BMW Motorrad USA Service Information Bulletin

****Notice of Recall 14V-211****

Subject: Retainer for Radial Shaft Seal

Model: R 1200 GS (K50, 0A01/0A11)

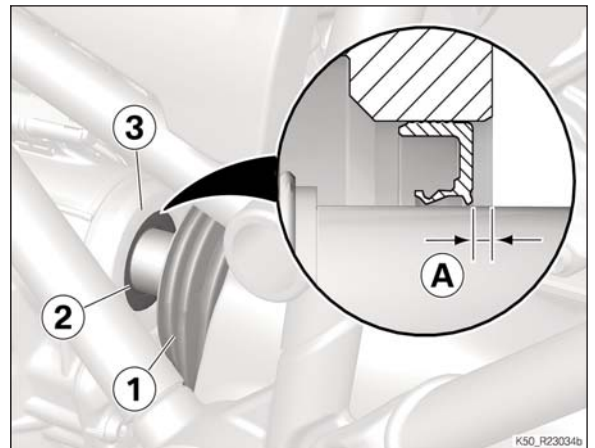
Lay a precision straight-edge across shaft sealing ring (2), resting at both ends on gearbox cover mating faces (3).

Check recess (A), shaft sealing ring (2) must be recessed or at most flush.

Shaft sealing ring projects past gearbox cover shows signs of rubbing or leaks.

Replacing radial shaft seal of output shaft (description in work item: 23 12 620, to be billed as a separate item).

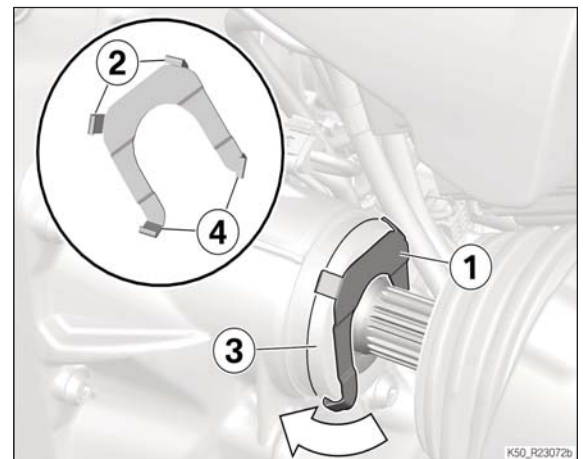
Hold retainer (1) with top hook (2) in position on gearbox cover (3).

Press retainer (1) at bottom, if necessary with a suitable tool, firmly against gearbox cover (3).

Bottom hooks (4) engage.

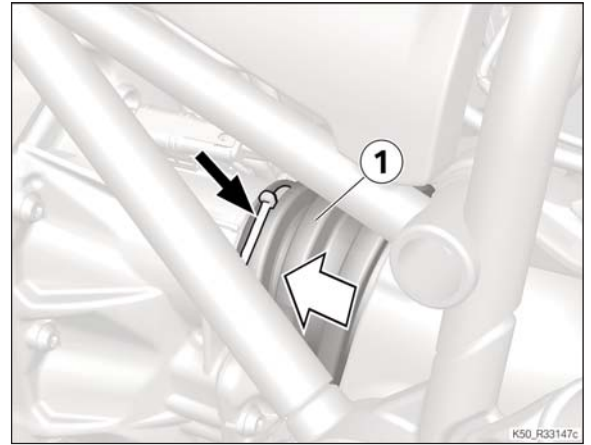
Work flexible gaiter (1) forward.

Install the cable tie (arrow).
